**PRELIMINARY DRAINAGE REPORT
FOR
STERLING RANCH PHASE 2 PRELIMINARY PLAN**

**August, 2021
Project No. 25188.02
SP-20-003**

**Prepared By:
JR Engineering, LLC
5475 Tech Center Drive, Suite 235
Colorado Springs, CO 80919
719-593-2593**

DRAINAGE MAP
 STERLING RANCH FILING 2
 JOB NO. 25188.01
 4/16/21
 SHEET 1 OF 6

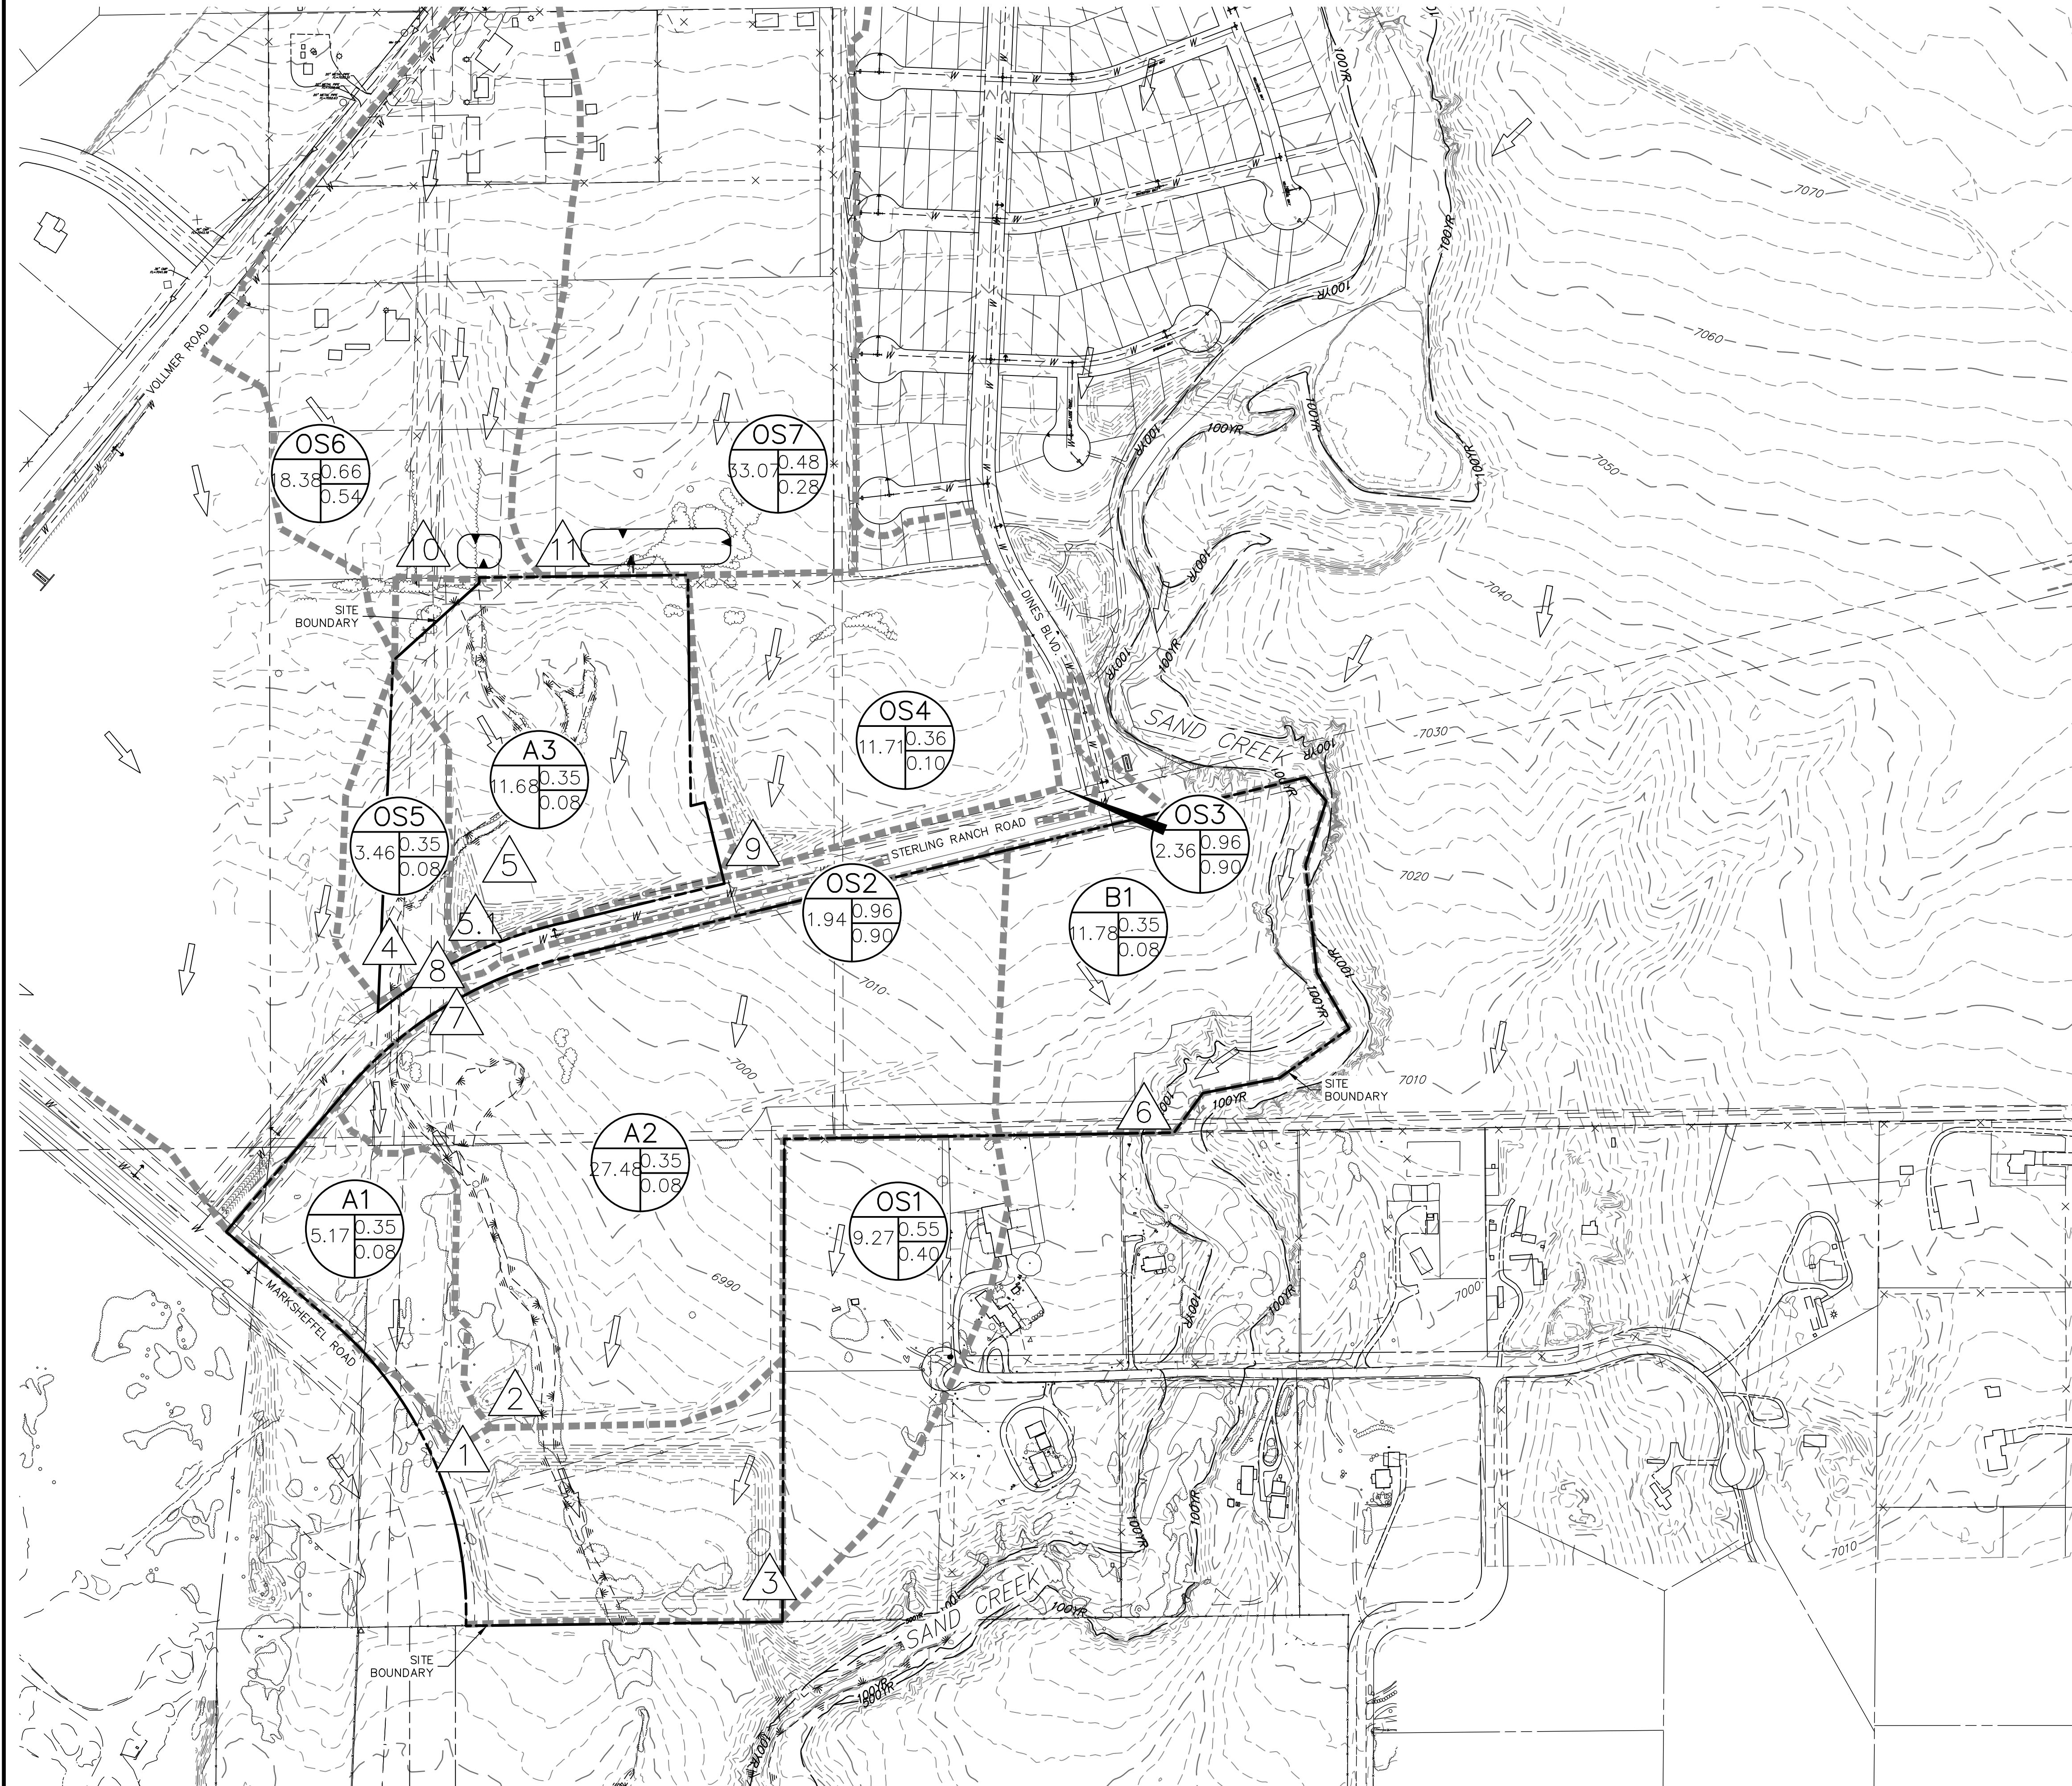
use latest plan

STERLING RANCH PHASE 2
 PROPOSED DRAINAGE MAP
 JOB NO. 25188.00
 07/30/21
 SHEET 1 OF 2

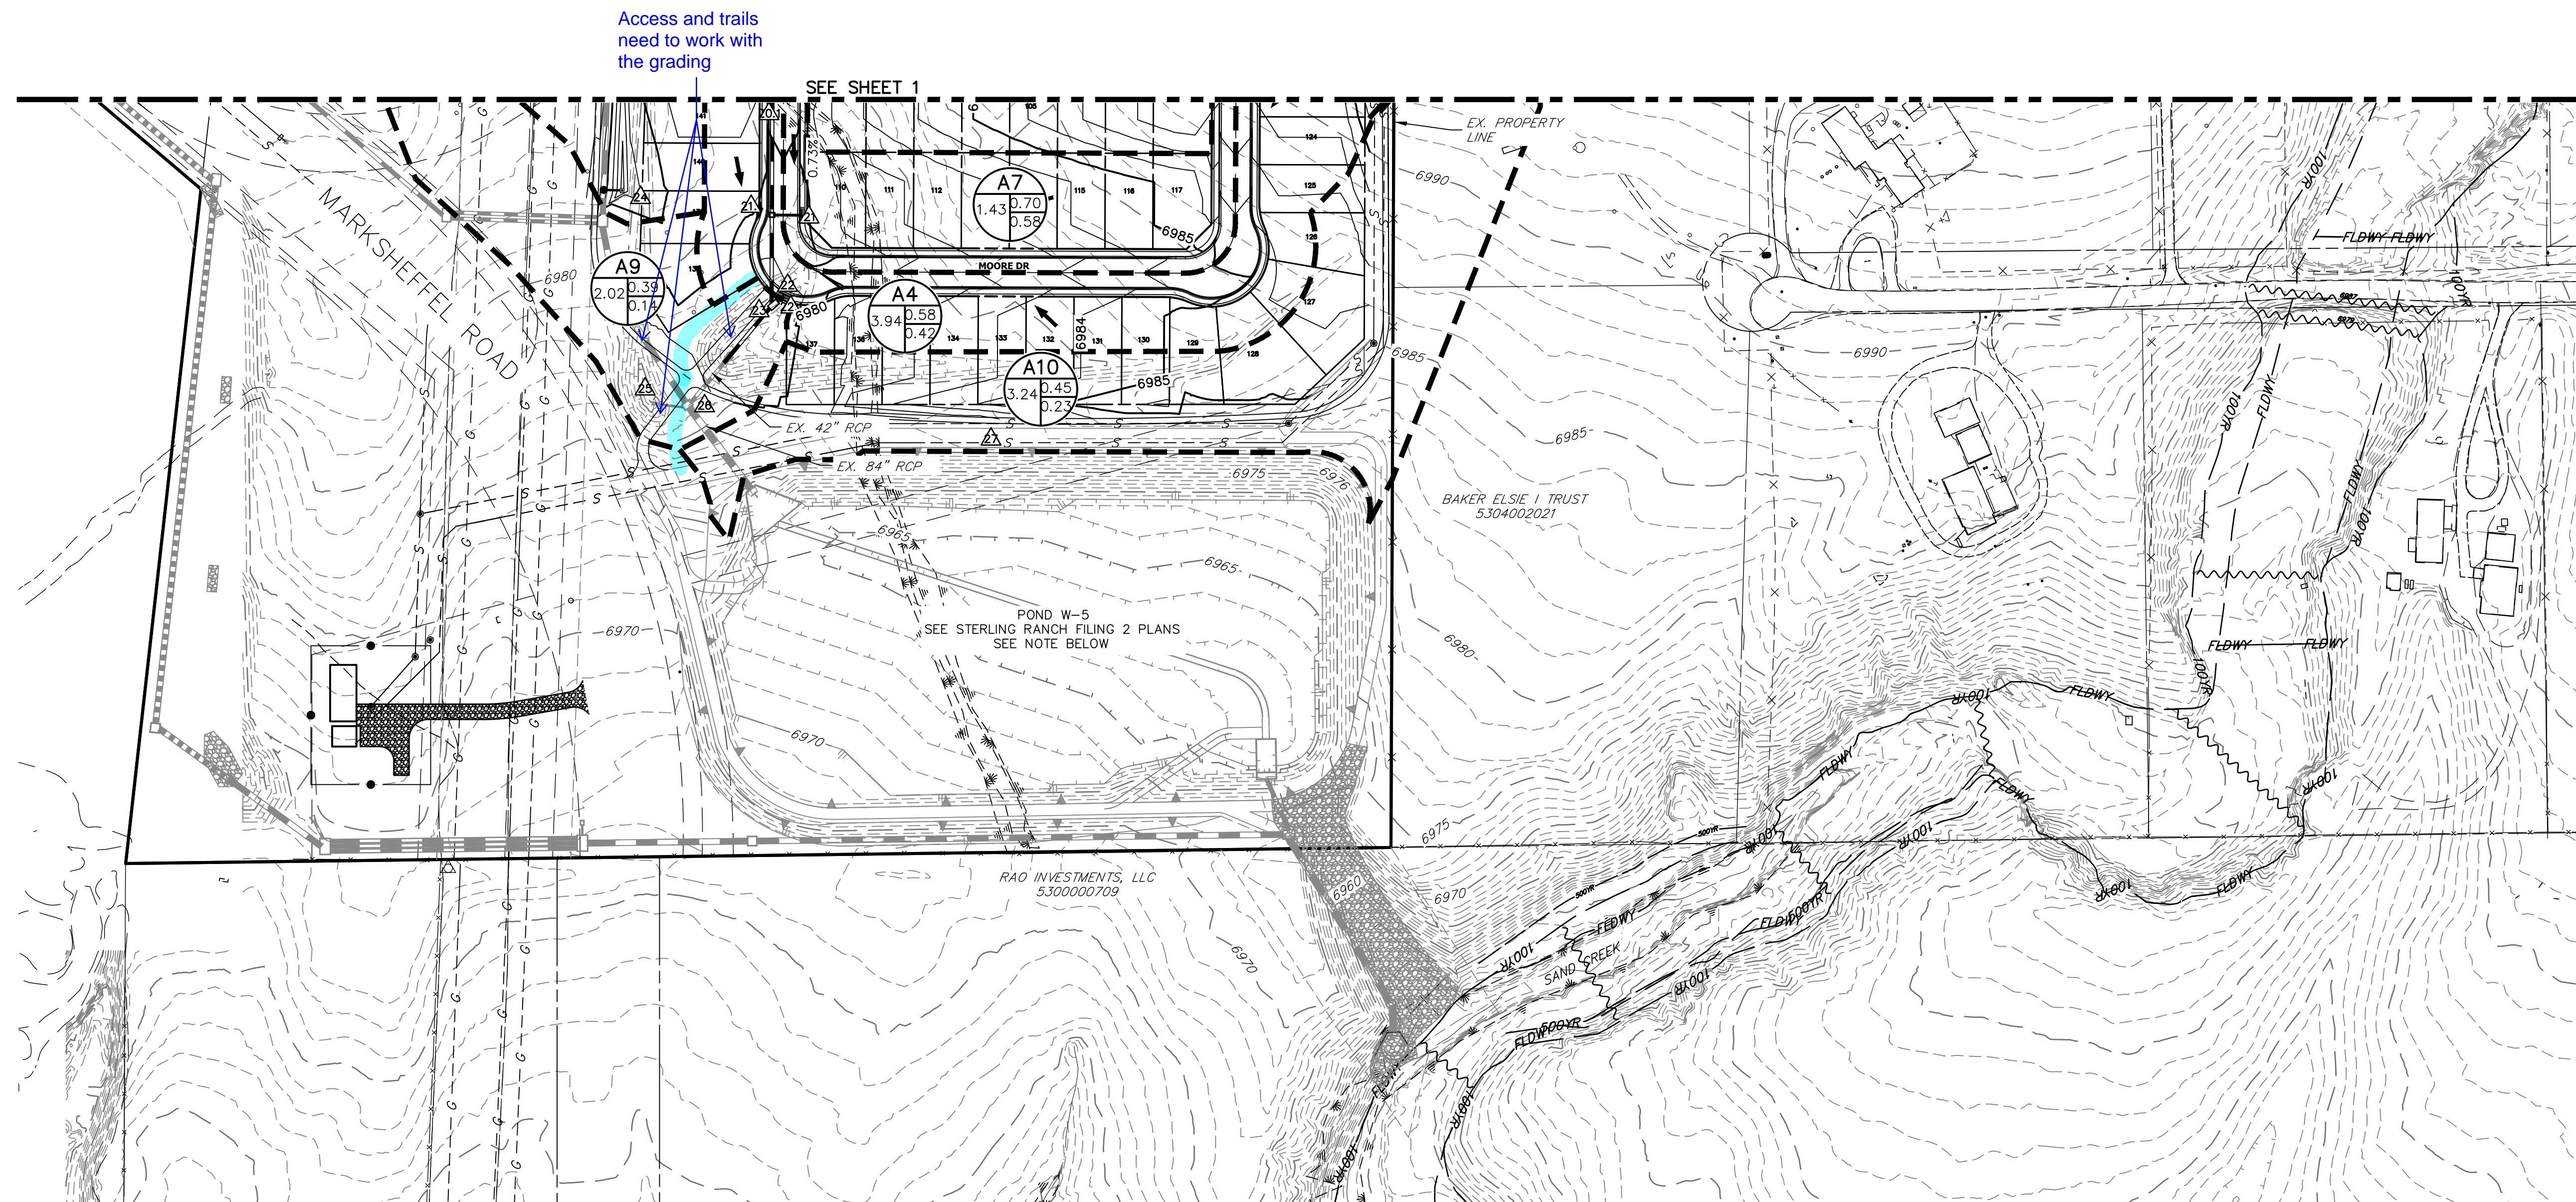
Access and trails
need to work with
the grading
